7. COA-084901-2021

306 North 26th Street

Commission of
Architectural Review

STAFF REPORT

Figure 1. View of window from North 25th Street

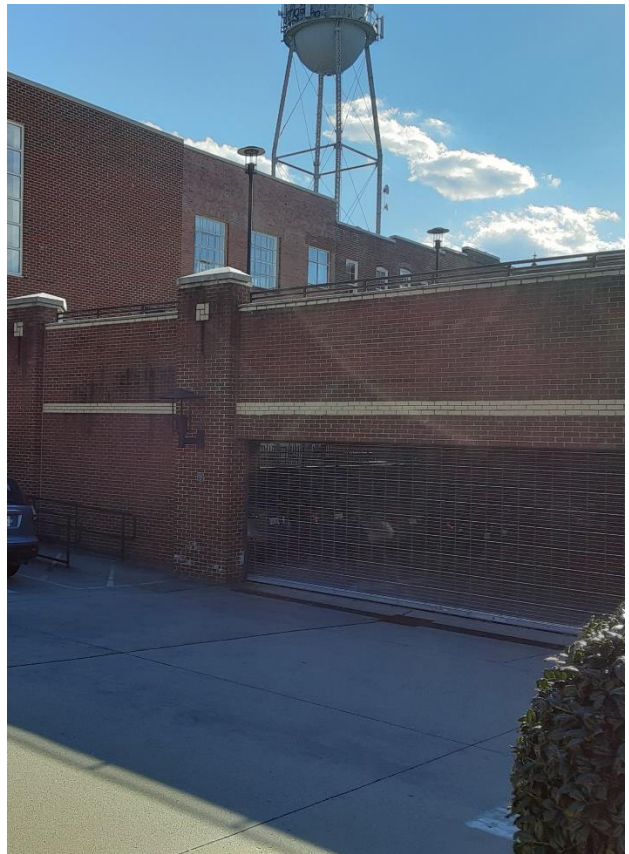
Staff understands that the applicant is concerned about the condition of the windows and is interested in replacing the existing window with a different design that matches another window in the unit. However, staff finds that this is the historic window design. Staff finds that changing this design to a different design would suggest an inaccurate evolution of the building. As such, staff recommends denial of the request to replace this existing window with a different design.

The applicant proposes to replace the existing metal frame window that does not have any divided lights. The applicant requests to replace this window with a Fibrex, four-over-four window to match nearby windows.

Staff finds that this was historically a metal window. Staff notes that the Guidelines recommend against changing window materials and recommends against the use of Fibrex in this location.

Staff recommends denial of the proposed window replacement. Staff further recommends the applicant submit a complete window survey and specifications for a window that matches the existing material and design for administrative approval.

Finally, staff recommends that the applicant submit a complete window survey, and specifications for a window that matches the existing material and design for administrative approval.
